Office Action Summary	Application No. 10/707,045	Applicant(s) WEYERS ET AL.	
	Examiner JOHN F. RAMIREZ	Art Unit 3737

DETAILED ACTION

Figure 1

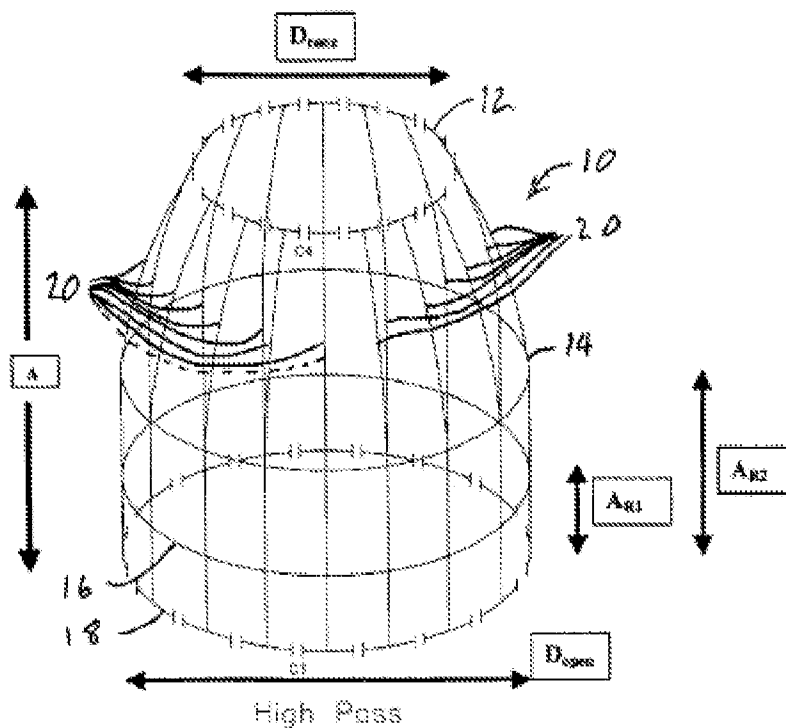
Reisker et al. teaches all the limitations of the claimed subject matter except for mentioning specifically an imaging coil comprising a plurality of capacitors have low impedance at frequency levels of at least 120MHz, wherein the end rings are closer to the radio frequency shield than the at least one center ring, and wherein the end rings are farther away from the patient bore than the at least one center ring.

However, an imaging coil comprising a plurality of capacitors have low impedance at frequency levels of at least 120MHz, wherein the end rings are closer to the radio frequency shield than the at least one center ring, and wherein the end rings are farther away from the patient bore than the at least one center ring are considered conventional in the art as evidenced by the teachings of Burl et al. and Petropoulos et al.

The Petropoulos et al. patent teaches plurality of capacitors have low impedance at frequency levels of at least 120MHz (see fig.10, C1, C4; col. 2 lines 1-41), wherein the end rings are closer to the radio frequency shield than the at least one center ring (see figures 1 and 4), and wherein the end rings are farther away from the patient bore than the at least one center ring (see figures 1-10). Moreover, Burl et al. teaches plurality of capacitors have low impedance at frequency levels of at least 120MHz (col. 5, lines 35-51).

Additionally, the limitations in which the end rings are closer to the radio frequency shield than the at least one center ring, and wherein the end rings are farther away from the patient bore than the at least one center ring are a change

in the shape of a prior art device, therefore is a design consideration within the skill of the art. In re Dailey, 357 F. 2d 669, 149 USPQ 47 (CCPA 1966).
